THE PINNACLE CLUB OF GROVE CITY AMENDMENT STATEMENT
DEVELOPMENT STANDARDS TEXT
SUBAREA E AMENDMENT
October 4, 2012

**THE PINNACLE CLUB
 SUB AREA "E"
 DEVELOPMENT PLAN
 CITY OF GROVE CITY, OHIO**

DRAWING NO. **SP01**
 SHEET 1 OF 2

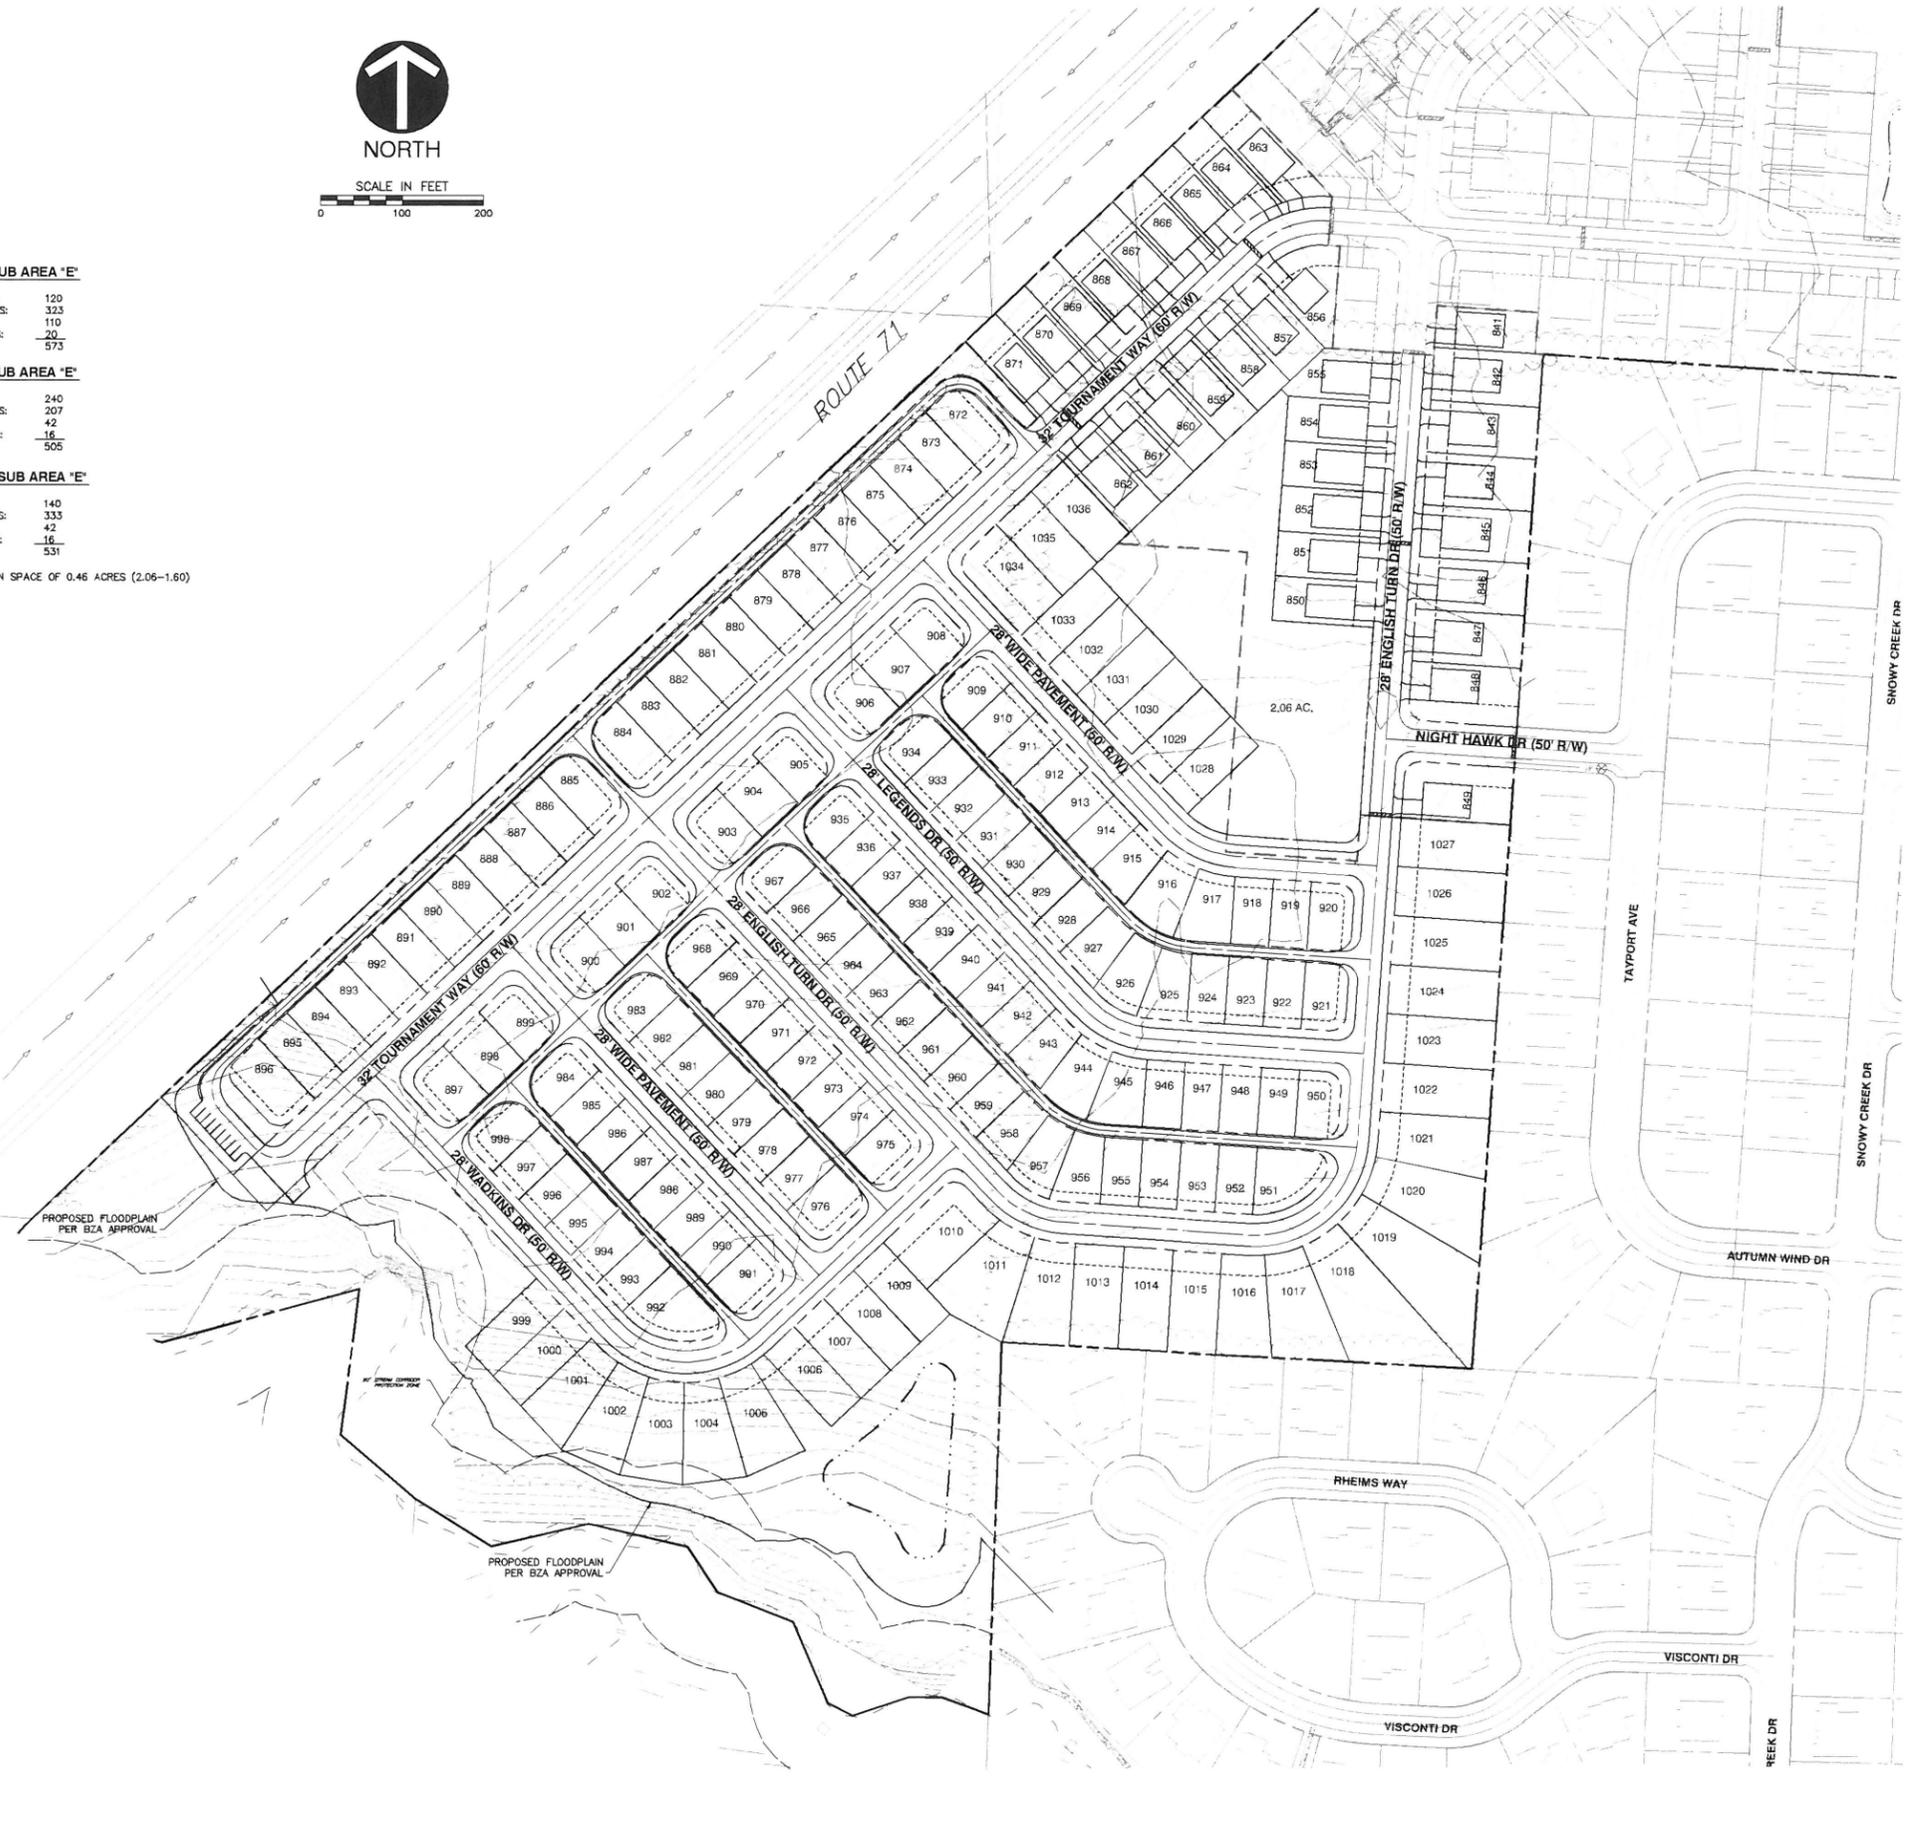
ORIGINAL SUB AREA "E"

VILLAGE HOMES:	120
CARRIAGE HOMES:	323
TOWN HOMES:	110
COTTAGE HOMES:	20
TOTAL:	573

CURRENT SUB AREA "E"

VILLAGE HOMES:	240
CARRIAGE HOMES:	207
TOWN HOMES:	42
COTTAGE HOMES:	16
TOTAL:	505

PROPOSED SUB AREA "E"

VILLAGE HOMES:	140
CARRIAGE HOMES:	333
TOWN HOMES:	42
COTTAGE HOMES:	16
TOTAL:	531

ADDITIONAL OPEN SPACE OF 0.46 ACRES (2.06-1.60)
